APPROVED

Limited building only review
Permit holder responsible for
full compliance with the code

THE NICHOLAS

BVA BUILDERS

FRONT ELEVATION

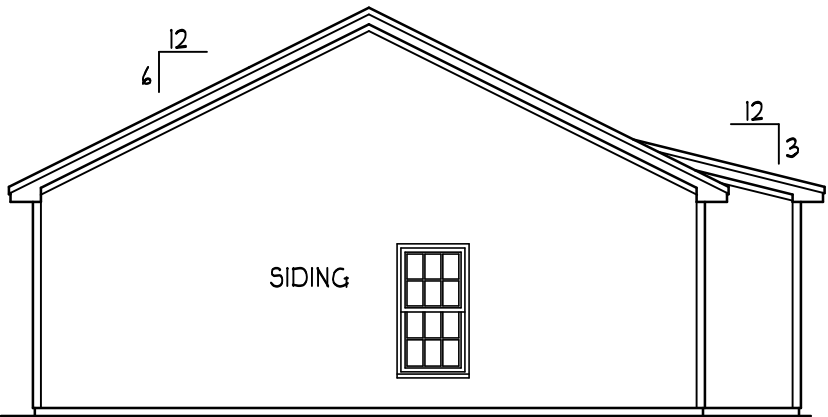
*SHOWN AS
MONO SLAB

HEADER/BEAM & COLUMN NOTES

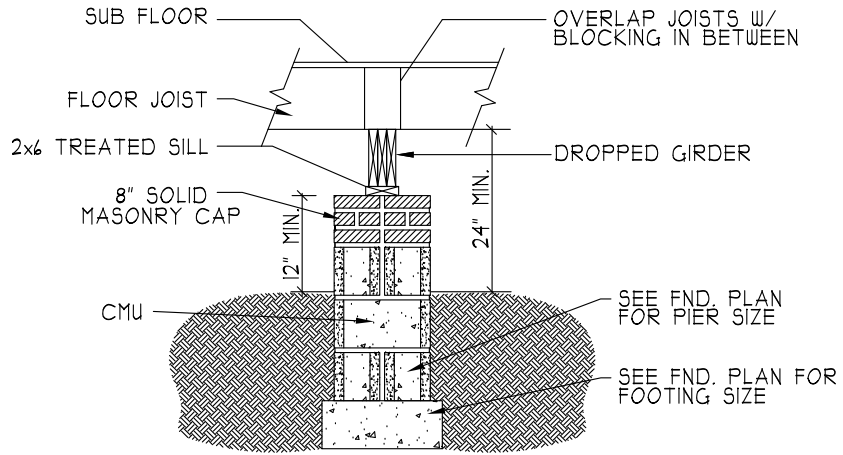
Shall be code
compliant and
insulated
